ASSESSMENT OF PARKING & TRAFFIC IMPACTS ASSOCIATED WITH
SECTION 4.55 APPLICATION
APPROVED MIXED USE DEVELOPMENT
52 – 62 MAY ROAD, NARRAWEENA

This Practice has been engaged by May Road Group / JV Urban to undertake an assessment of the parking and traffic impacts associated with a Section 4.55 Application for alterations to an approved mixed-use development at 52 – 62 May Road, Narraweena.

SCHEDULE OF CHANGES
S4.55 ISSUE

DRAWING TITLE
PLANS - GENERAL ARRANGEMENT BASEMENT 1

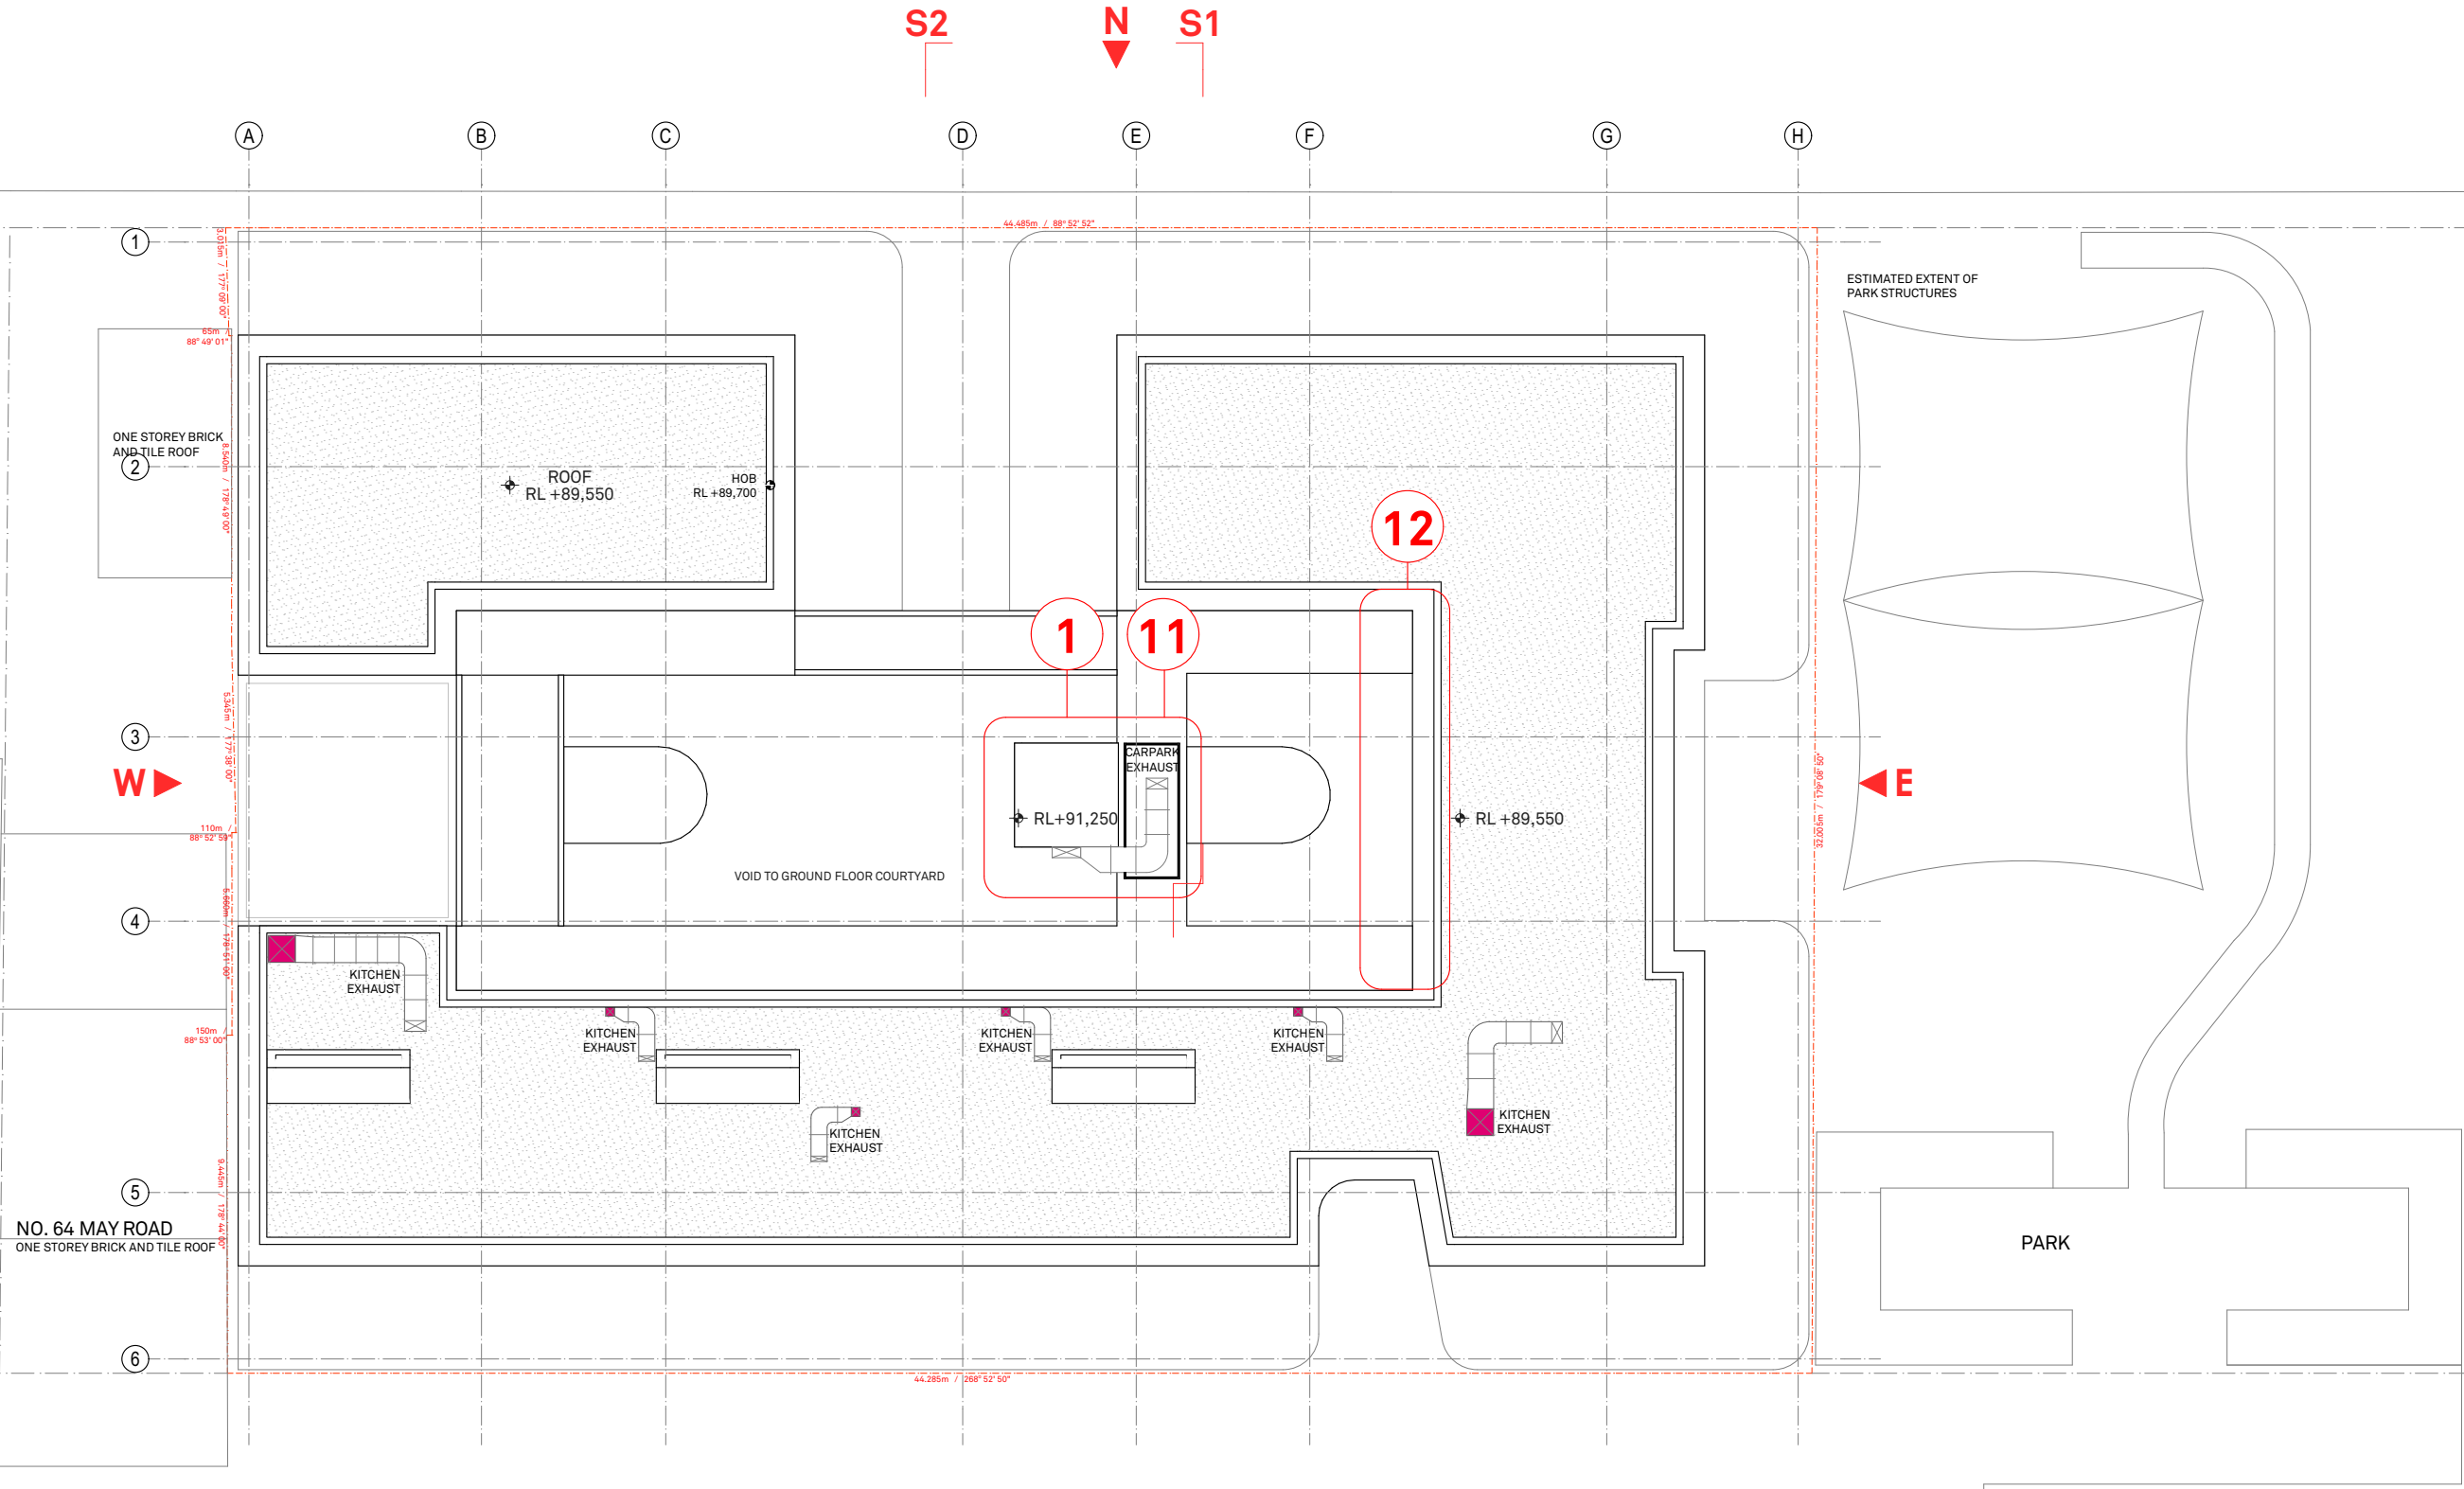
1. Relocation of the lift core to a more centralised location within the courtyard.

11. Carpark exhaust relocated adjacent to the new position of the lift core.

12. Awning amended according to changes with circulation path below.
